## Proposal for the 03 series of amendments to UN Regulation No. 127 (Pedestrian safety)

The text reproduced below was prepared by the experts from OICA to amend the definitions and specifications as well as the Annex 1, Part 1. It is a revised counterproposal to document ECE/TRANS/WP.29/GRSP/2019/18 submitted by Germany. It also replaces the OICA informal documents GRSP-67-07 and GRSP-68-18.

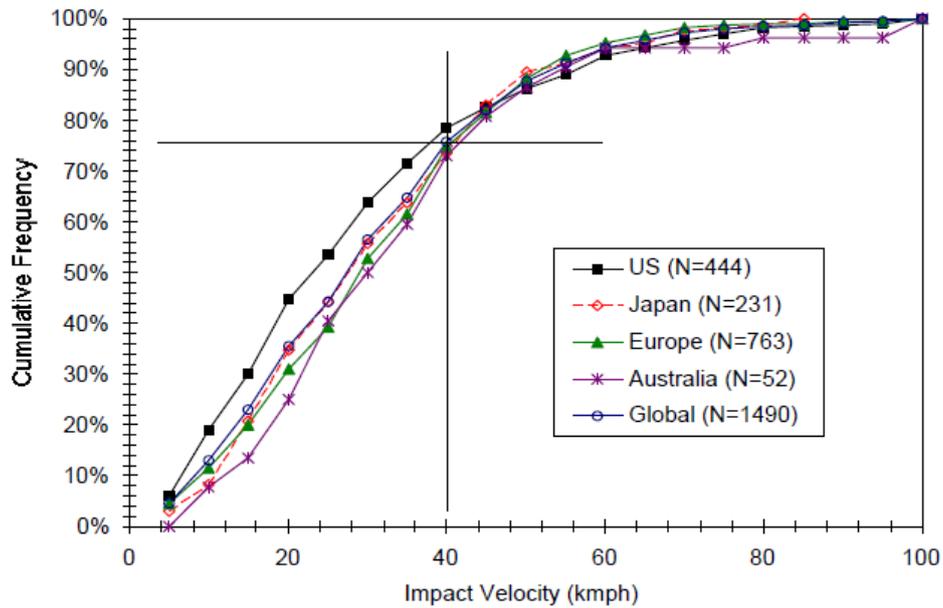
1. UN Regulation No. 127 addresses impacts with a pedestrian up to 40 km/h. Therefore, an impact velocity of 11.1 m/s (40 km/h) has been chosen to address a large amount of Maximum Abbreviated Injury Scale 1+ pedestrian accidents (see diagram below).
2. As pointed out by Germany in document ECE/TRANS/WP.29/GRSP/2019/18, the availability of active suspensions allows the development of a system which could change the vehicle height while driving (up to a defined driving speed, e.g. up to 39 km/h). Such a system would allow raising of the suspension for driving off road (SUVs mostly) or driving in a car park (sports cars). In this context, there have been discussions with some manufacturers about the relevance to pedestrian protection. Since the vehicle height has an influence on the headform test area (WAD) and on the test results for legform tests, Germany

considers that all possible vehicle heights up to a driving speed of 11.1 m/s (40 km/h) should be considered to be relevant for impact with a pedestrian. The proposal clarifies this issue.
